Entergy Nuclear Operations, Inc.
Pilgrim Nuclear Power Station
600 Rocky Hill Road
Plymouth, MA 02360

SUBJECT: Entergy Nuclear Operations, Inc.
Pilgrim Nuclear Power Station
Docket No. 50-293, License No. DPR-35

Response to NRC Request for Additional Information Related to Third Ten-Year Pilgrim Relief Request, PRR-42, Examinations of Component Welds with Less Than Essentially 100% Examination Coverage

LETTER NO. 2.07.076

DATA SHEET # 03-M-064
COMPONENT # GB 10-9-2E
PAGE 2 OF 2

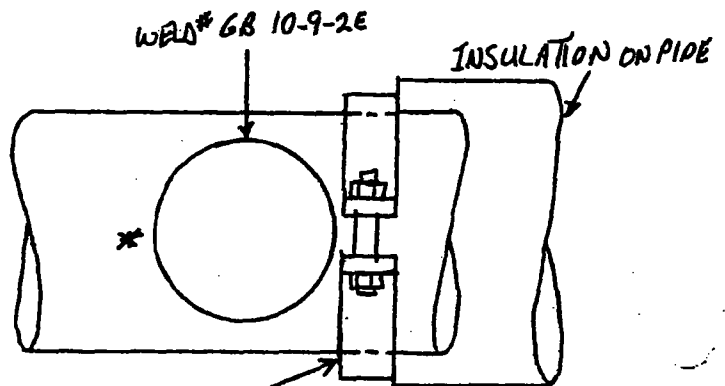
2.10.2 *In addition, the licensee has reported 63.8% volumetric coverage for Weld GB-10-9-2E, which is described as a "weldolet", and a cross-sectional sketch is included on page 233. However, from this sketch, Weld GB-10-9-2E appears to be a branch connection (Item C5.81) configuration similar to that shown in ASME Figure IWC-2500- 12. As such, only a surface examination is required to be performed on this weld. Please confirm whether this weld is a full penetration circumferential butt weld, or a branch connection, as shown in the licensee-submitted sketch.*

The configuration of weld GB-10-9-2E consists of a vertical 12-inch diameter weldolet (16.9-inch diameter) joining line 12"-GB-10 to a horizontal 18-inch diameter carbon steel pipe (line no. 18"-GB-10) in the RHR System. This configuration is depicted on drawing ISI-I-10-4B Sheet 1 and is a branch connection using a circumferential full penetration fillet weld to connect the weldolet to the 18" diameter run pipe, similar to Figure IWC-2500-10. As such, this weld should have been classified as Examination Category C-F-2 Item No. C5.81 instead of Item No. C5.51. The required examination method for this weld is surface only per Table IWC-2500-1. The last inspection of this weld consisted of both surface (MT) and volumetric (UT) examinations.

The station's ISI tracking database has been updated to reflect Code Item No. C5.81 as being the correct classification for this weld. Any future examinations at this location will consist of the MT surface examination method only. As stated in the response to RAI Question 2.10.1, the last magnetic particle (MT) surface examination of this weld (reference datasheet 03-M-064) yielded a combined coverage of 85% due to a large pipe clamp obstructing access to portions of the weld inspection boundary. The use of the PT (liquid penetrant) method does not provide an appreciable gain in the 90% required coverage. Due to the remote location of the obstructing pipe support in the ceiling of the Torus Room, no practical means exists to temporarily support this pipe so that the clamp can be loosened and moved, or completely removed, to provide increased inspection access to weld GB-10-9-2E. As such, future MT surface examinations are expected to average 85% coverage only.

Pilgrim ^{-N7A&B}
 Weld RPV ~~N7A-NV~~
 Top Head Spray

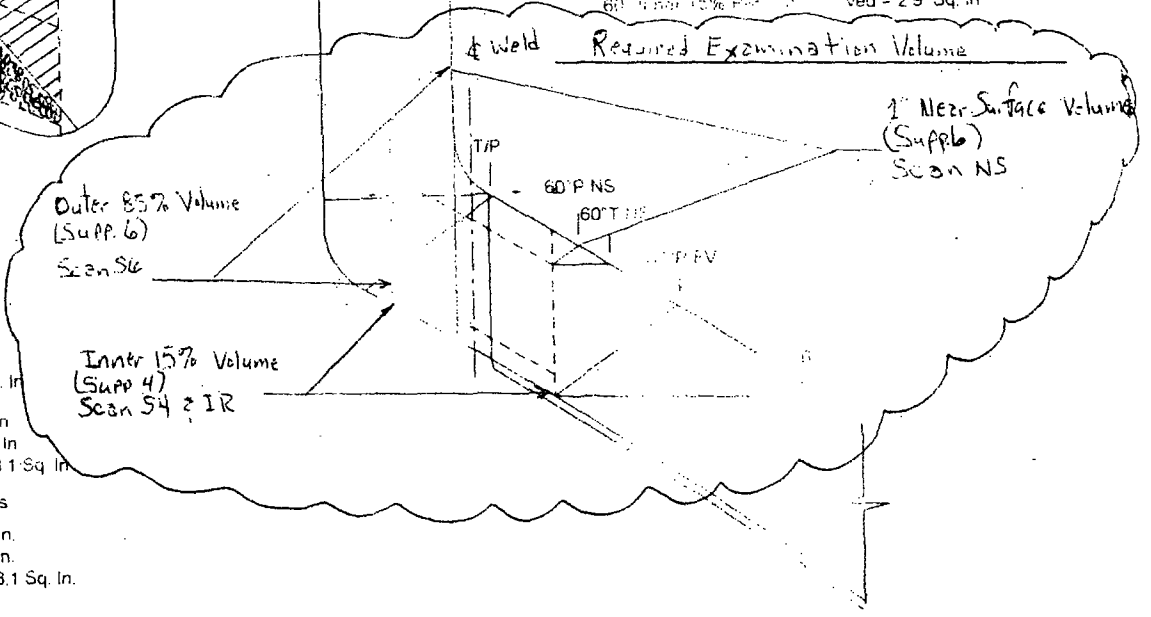
Limitations in weld coverage were identified due to the nozzle configuration (proximity to the weld). This limitation exists at varying degrees for the entire weld length. The limitation locations are identified for the top and bottom side of the nozzle to contrast the configuration differences at these two extreme locations. Report Nos. PIL-R15-05-026 and 028 indicate identical coverage and will be discussed together. Modified coverage sketches from Report No. PIL-R15-05-026, identified as Sketch 3 is included in Attachment A and indicates the weld examination volume required by ASME Section XI, Appendix VIII Supplements 4, 5 & 6. These sketches also indicate the limited coverage areas for both the T and P scans. The Table on page 7 of 8 of Report Nos. PIL-R15-05-026 & 028, summarize the limitation percentages. Note that there were no limitations associated with the inner radius and inner 15% volume coverage (these areas received 100 % coverage by either or both of the Supplement 4 and 5 scanning techniques).
